CITY OF GARDEN CITY

File Number: DSRFY2022 - 0022
Application Scope: Formal Hearing
Location: 233 & 311 E. 47th Street
Applicant: Katrina Klum
Pre-Application Report Date: September 8, 2022
Formal Hearing Date: February 6, 2023

Staff Report
 Prepared by Hanna Veal

1 bldg A - entry
 1/8" = 1'-0"

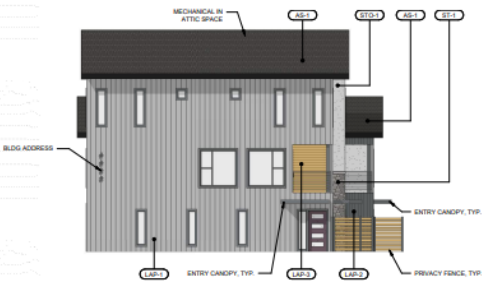
1. Northern property line doesn't have trees due to the open Thurman Mill irrigation.
2. Street elevation of the units closest to 47th street are required to address the street. End unit could be a unique structure or design.
3. Identify of the development's back structures are lost. There isn't a street, or a courtyard for the units to focus on. What is their amenity?
4. Terminal views need to end in landscaping and beautification as opposed to dwelling unit garages. Is there opportunity where drive isle can become common open area with multi-uses?
5. Rooflines, hips, gables, and facial lines all need more depth and character.
6. Parking reduction needs to be justified. Transit line has been removed and no longer opportunity.
7. Pedestrian connectivity will be implemented through the long block in association with the adjacent property (DSRFY2022-2023).

- 2) Design of the structures:
 - a) Architecturally addressing the street;
 - b) Privacy;
 - c) Articulation, protrusions, glazing, fenestrations, etc.;
 - d) Property management office/post office/bicycle storage areas.

The updated schematic drawings show the facades of these spaces, which do not appear dominant or attention grabbing in the way one might be able identify its function. Discussion required.
Title 8, Chapter 4: Design and Development Regulations			
8-4A-3 Fences and Walls	DC	Complaint as Conditioned	<p>Site plans do not identify fencing. Renderings show perimeter fencing. Discussion required.</p> <p>Any future fence or wall will be required to be in compliance with code at the time of development.</p>
8-4A-4 Outdoor Lighting	DC	Complaint as Conditioned	Any future outdoor lighting will be required to be in compliance with code at the time of development.
8-4A-5 Outdoor Service and Equipment Areas	DC	Complaint as Conditioned	This proposal does not identify any outdoor service equipment. Any future outdoor service equipment area will be required to be in compliance with code at the time of development.
